Project	IEEE 802.16 Broadband Wireless Access Working Group < http://ieee802.org/16 >	
Title	Correction and simplification of downlink STC in PUSC	
Date Submitted	2005-01-26	
Source(s)	Yuval Lomnitz Dov Andelman Intel.	Yuval.Lomnitz@intel.com
	Yossi Segal Yigal Leiba Runcom Ltd.	
	Ran Yaniv Alvarion Ltd.	
Re:	IEEE P802.16REVd/D5-2004	
Abstract	Corrections and clarifications of definitions for STC in OFDMA PHY.	
Purpose	Adopt changes.	
Notice	This document has been prepared to assist IEEE 802.16. It is offered as a basis for discussion and is not binding on the contributing individual(s) or organization(s). The material in this document is subject to change in form and content after further study. The contributor(s) reserve(s) the right to add, amend or withdraw material contained herein.	
Release	The contributor grants a free, irrevocable license to the IEEE to incorporate material contained in this contribution, and any modifications thereof, in the creation of an IEEE Standards publication; to copyright in the IEEE's name any IEEE Standards publication even though it may include portions of this contribution; and at the IEEE's sole discretion to permit others to reproduce in whol

2.3. Delay

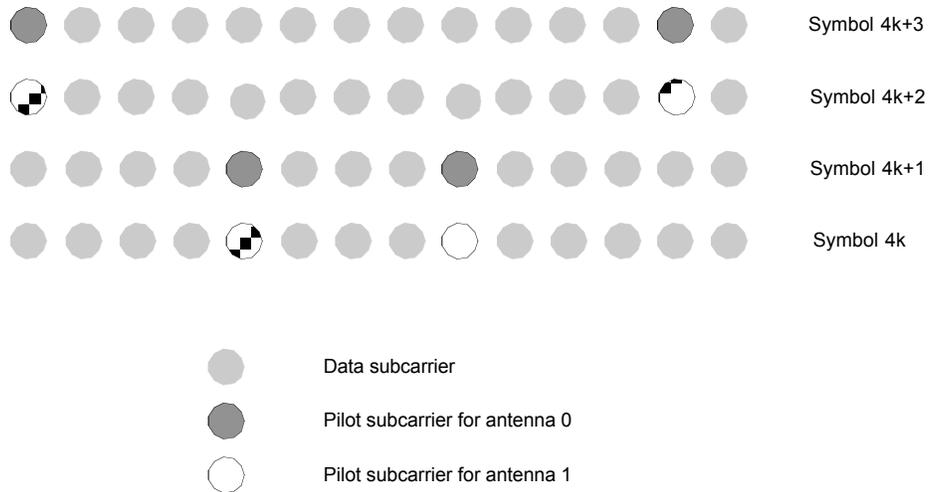
In addition, in the current definition STC is done over slots, which inserts an unnecessary delay and sensitivity to phase noise, puts an unnecessary constraint of the length of the STC zone (STC zone is required to be a multiple of 4 symbols instead of 2 – waste of up to 2 symbols) and differentiates between STC for FUSC and for PUSC.

Figure 245 – Cluster structure for STC PUSC using 2 Antennas

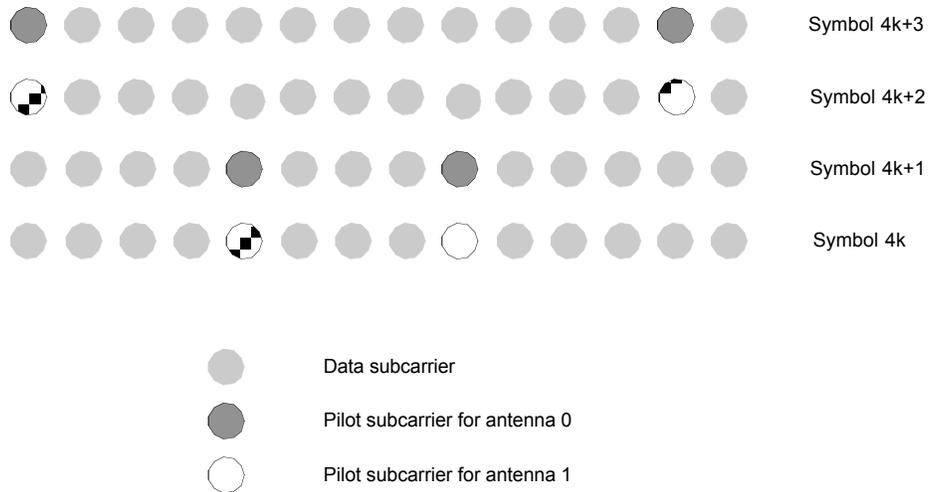
In PUSC the data allocation to cluster is changed (Figure 245) to accommodate two antennas transmission with the same estimation capabilities, each cluster shall be transmitted from each antenna.

Figure 245 replaces Figure 234 in the definition of PUSC permutation when STC is enabled. The pilot locations change in period of 4 symbols.

STC encoding is performed on the two symbols of the PUSC slot (Each even symbol with following odd symbol).

Figure 245 – Cluster structure for STC PUSC using 4 Antennas

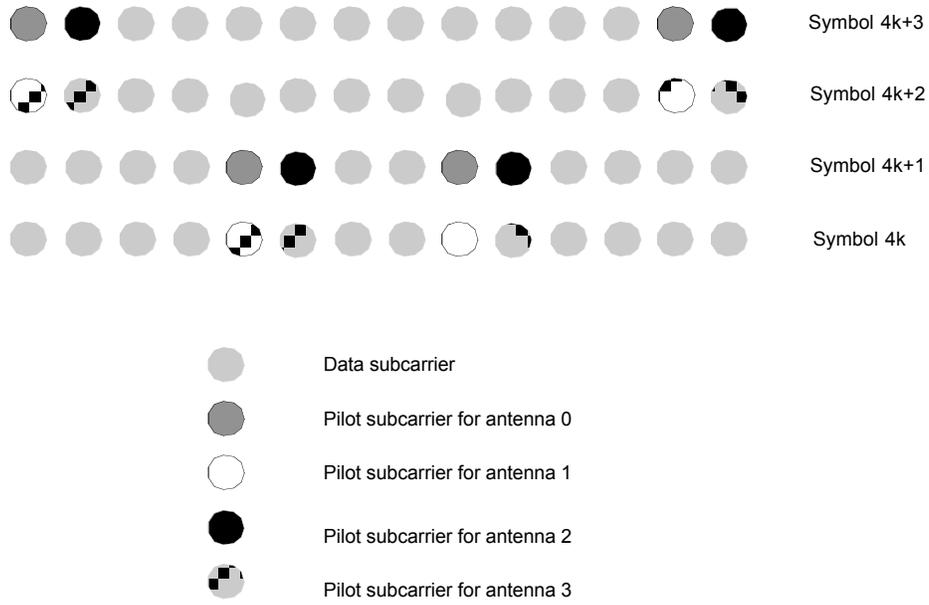
~~For~~For this configuration the basic cluster structure is changed as indicated in Figure 251 to ~~accommodate~~ accommodate the transmission from 4 antennas (pilots for antennas 2/3 override data subcarriers, the data puncturing for CC shall be performed after STC encoding and before subcarrier randomization. ~~in the even symbols, switching and erasing of the data subcarriers shall be performed after constellation mapping, therefore therefore maintaining all the encoding scheme and the subchannel allocation scheme).~~

[Replace figure 251]
